SUNDRY NOTICES AND REPORTS ON WELLS
Do not use this form for proposals to drill or to re-enter an abandoned well. Use form 3160-3 (APD) for such proposals.

1. Type of Well <input type="checkbox"/> Oil Well <input type="checkbox"/> Gas Well <input checked="" type="checkbox"/> Other: INJECTION		5. Lease Serial No. NMNM98122
2. Name of Operator LINN OPERATING INC		6. If Indian, Allottee or Tribe Name
Contact: TERRY B CALLAHAN E-Mail: tcallahan@linnenergy.com		7. If Unit or CA/Agreement, Name and/or No.
3a. Address 600 TRAVIS STREET, SUITE 5100 HOUSTON, TX 77002	3b. Phone No. (include area code) Ph: 281-840-4000	8. Well Name and No. SKELLY UNIT 12
4. Location of Well (Footage, Sec., T., R., M., or Survey Description) Sec 21 T17S R31E Mer NMP NWSE 1980FSL 1980FEL 32.818269 N Lat, 103.872587 W Lon		9. API Well No. 30-015-05324
		10. Field and Pool, or Exploratory GRAYBURG JACKSON;SR-Q-G-S
		11. County or Parish, and State EDDY COUNTY, NM

PROPOSED PLUGGING PROCEDURES:

Well Name: Skelly Unit 12

Proposed Wellbore Diagram

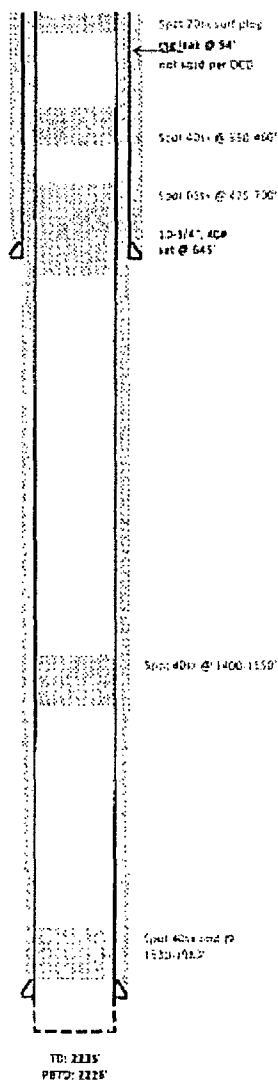
- MIRU PLUGGING EQUIPMENT
- SPOT 40 SXS CMT @ 1980-1830. WOC & TAG. CIRC HOLE W/ MUD LADEN FLUID.
- SPOT 40 SXS CMT @ 1550-1400. (BTM OF SALT). *Perf & Attempt to SQZ. WOC Tag.*
- SPOT 65 SXS CMT @ 700-475. WOC & TAG (SHOE & TOP OF SALT). *Perf & Attempt to SQZ.*
- SPOT 40 SXS CMT 460-360. *Perf & Attempt to SQZ.*
- SPOT 20 SXS CMT SURFACE PLUG. *Perf & SQZ from 60' - surf.*
- CUT OFF WELL HEAD AND WELL ON DRY HOLE MARKER.

*At cut-off verify ent to surf all
annulus, may require remedial on
10 3/4" annulus.*

Ground level Dry Hole Marker Reg.
